3 January 2019
Our Ref: 9903A.9ER_RFI for main DA

DA2017/0657
47-69 Woids Avenue, Allawah
Alterations and additions to existing school

The following response has been prepared by DFP Planning, on behalf of St George Christian School in response to Council's email of 28 May 2018, wherein further information in respect of the development application (DA) for alterations and additions to the existing school at 47-69 Woids Avenue, Allawah was requested. This letter also responds to the matters raised by the Sydney South Planning Panel at the briefing meeting with Council on 8 May 2018.

Figure 3 Extract from height plane plan for amended DA proposal

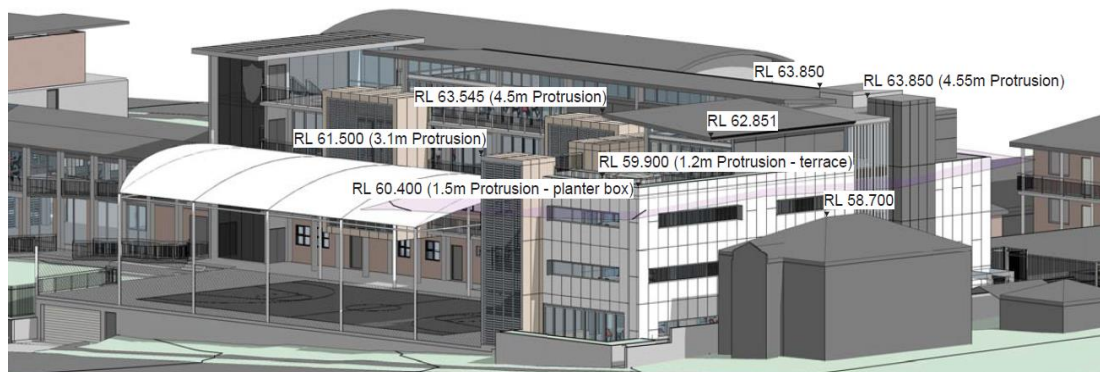
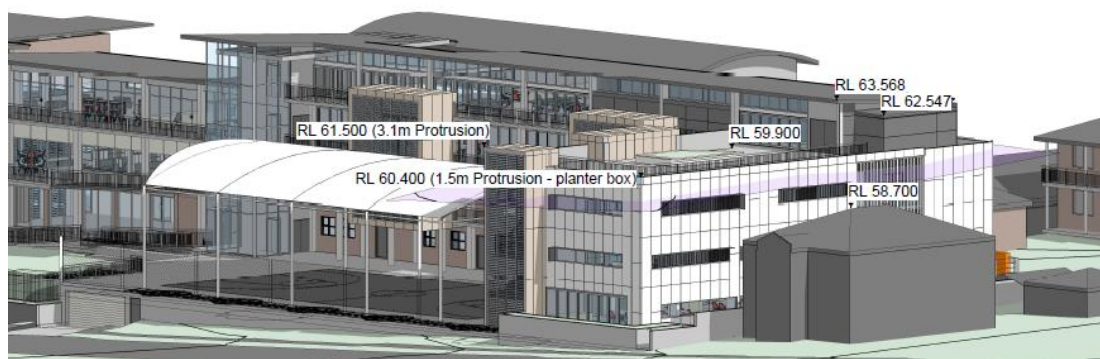
The development has been modified to reduce the building height adjacent to No. 45 Woids Avenue however the building on that part of the school zoned R2 will still exceed the 9m building height limit. And in terms of FSR, the quantum of gross floor area (GFA) on this part of the site will still result in development which exceeds the FSR control that applies to this part of the site under Kogarah LEP 2012.

Based on the amended proposal, the maximum extent of the breach of the 9m building height limit is 4.215m (being the top of the skillion roof over the staff room area which sits at RL63.568). This part of the building is setback 8.03m from the boundary with 45 Woids Avenue. The extent of height breach of the amended development is less than that of the originally proposal. To assist Council in comparing the two schemes, **Figures 2 and 3** are a comparison of the height plane plan for the original proposal and the height plane plan for the amended development proposal. What is not readily apparent in **Figures 2 and 3** is the increased setback to the northern boundary with 45 Woids Avenue.
